CITY OF ALBUQUERQUE

RE: **Campbell Compound**
Drainage Report and Grading Plan
Engineer's Stamp Date 9/26/17
Hydrology File: G13D032

DRAINAGE REPORT

**RE: G13D032 - Campbell Compound
Grading Plan & Drainage Report
Zone Atlas Map: G-13**

DRAINAGE BASIN EXHIBIT

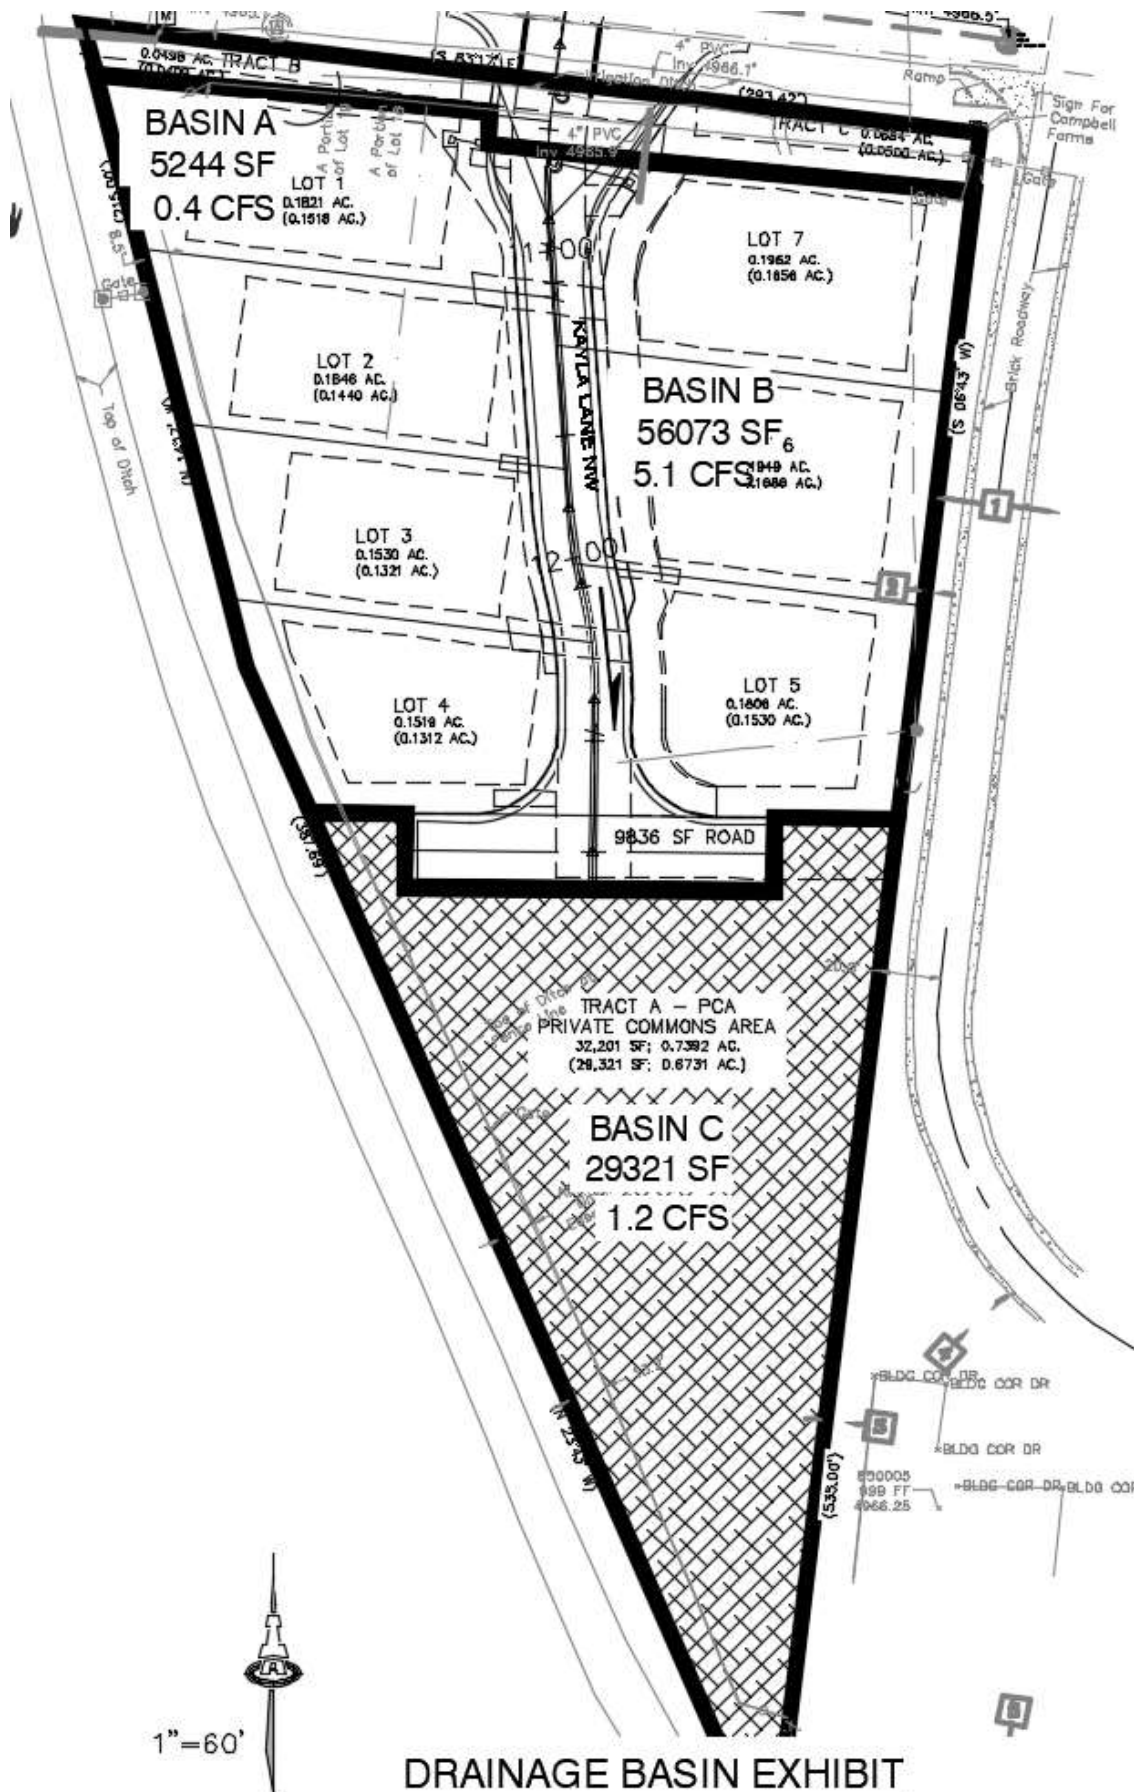
3. Offsite Flows. Runoff and volume calculations need to anticipate flows entering this site from the Conservancy berm and its access road along the east side of the Campbell Community Ditch. It is difficult to tell from the basin map if this area was included.

3. There appear to be no offsite flows from the walkway at the ditch berm. The basin extends to the top of the berm, then the walkway slopes west.
4. Since no additional grading will occur in Tract A, land treatment A was not adjusted.
